# U.S.A. RECALL CAMPAIGN No. 47

## Ferrari 612 Scaglietti F1

### Replacement of the Clutch Sensor in the F1 Transmission.

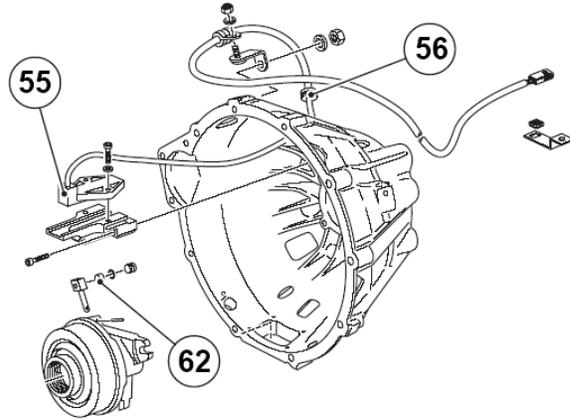
Replacement of the clutch sensor - Part No.: **182311**- with the **new F1 clutch sensor Kit Part No.: 70001323** (244801 with standard connector), Fig. 1.

Replacement of the clutch sensor - Part No.: **206075**- with the **new F1 clutch sensor Kit Part No.: 70001324** (243784 with waterproof connector), Fig. 2.

- › **Complete clutch sensor kit, F1 gearbox, Part no. 244801 (with standard connector);**
- › **Complete clutch sensor kit, F1 gearbox, Part no. 243784 (with waterproof connector);**

- Ref. 55 Sensor
- Ref. 56 Cable holder
- Ref. 62 Magnet

I. Replace the F1 clutch sensor (as described in chapter D3.01 of the Workshop Manual), fitting the new one in relation to the different vehicle groups as indicated on page 1.

II. Connect the SD3 tester to the vehicle diagnostic socket and perform the following operations:

II a) - Bleed the electronically-controlled gearbox clutch system (as described in chapter D3.04 of the Workshop Manual).

II b) - Access the ACTIVE DIAGNOSIS environment and run a “SELF-LEARNING” cycle.

II c) - Access the ERROR environment and “DELETE THE ERRORS”, then disconnect the SD3 tester.

III. Road-test the vehicle ( “free drive test”) for approximately 10 minutes, in order to ensure that the vehicle functions properly.
